05 Hydraulic valve clearance compensating elements

05 Hydraulic valve clearance compensating elements

05 Timing chain

P05-0175-13

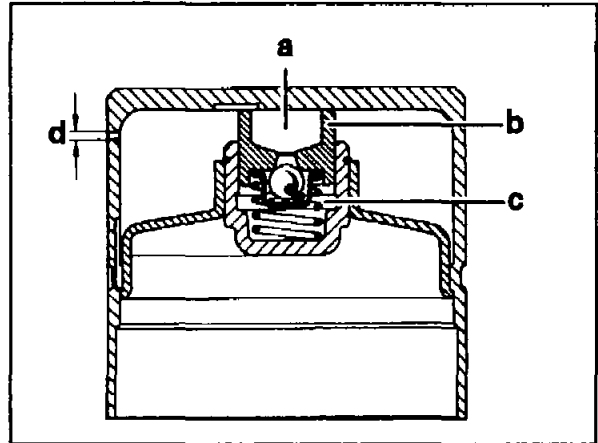
Noises from hydraulic valve clearance compensating elements for short time after starting engine.

Some of the oil can run out of the hydraulic elements when the engine is started and shut off frequently or after it has remained shut off for a longer period, e.g. over night, resulting in noises for a short time after starting.

Install modified bucket tappets, part no. 601 050 05 25.

These compensating elements have a reduced residual stroke, i.e. the piston stroke (9) and the working chamber (c) have been reduced increasing the size of the reservoir chamber (a). Less oil is required in the working chamber due to the reduced stroke. For this reason the working chamber refills more quickly when the engine is started.

P05-2206-13

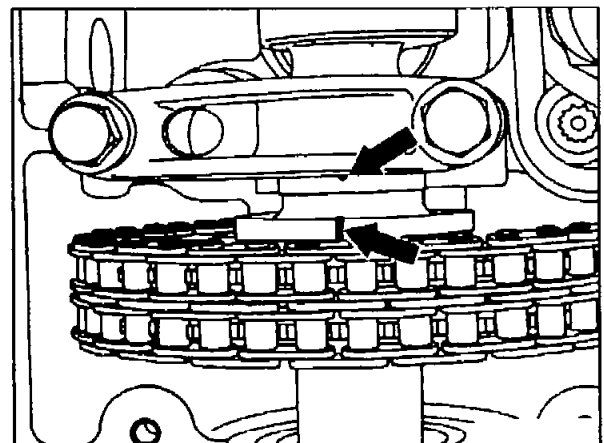
Engine problems as a result of stretched timing chain.

If the following problems exist, the timing chain must be inspected for stretch:

1. Slowly rotate the crankshaft in direction of rotation of engine until the markings of the camshaft and bearing bracket are aligned.
2. Read off the difference in degrees crank angle ($^{\circ}$ CA) at the crankshaft belt pulley. For engine 604/605/606 see AR 05.20-6010 HA).
 - a) If difference is 3° to 10° CA, the timing chain should be replaced.
Engine 601/602/603 (RA 05.10-320)
Engine 604/605/606 (AR 05.10-7601 HA)

P05-5498-15

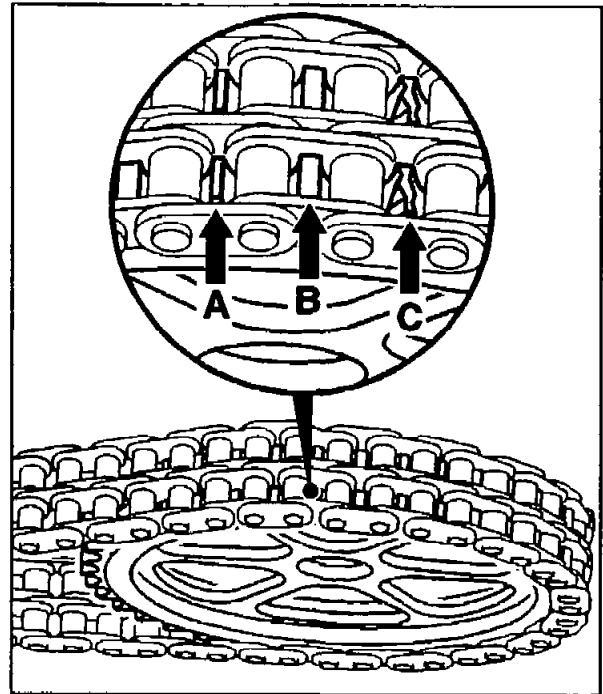
b) Inspect all the teeth of the camshaft sprocket for signs of wear. Crank the engine twice at the crankshaft for this purpose. Specified condition arrow B. If teeth tips are broken off (arrow C), or wear at tooth flanks (arrow A), replace camshaft sprocket and timing device.

On engine 604 replace camshaft sprocket and drive gear of distributor-type injection pump.
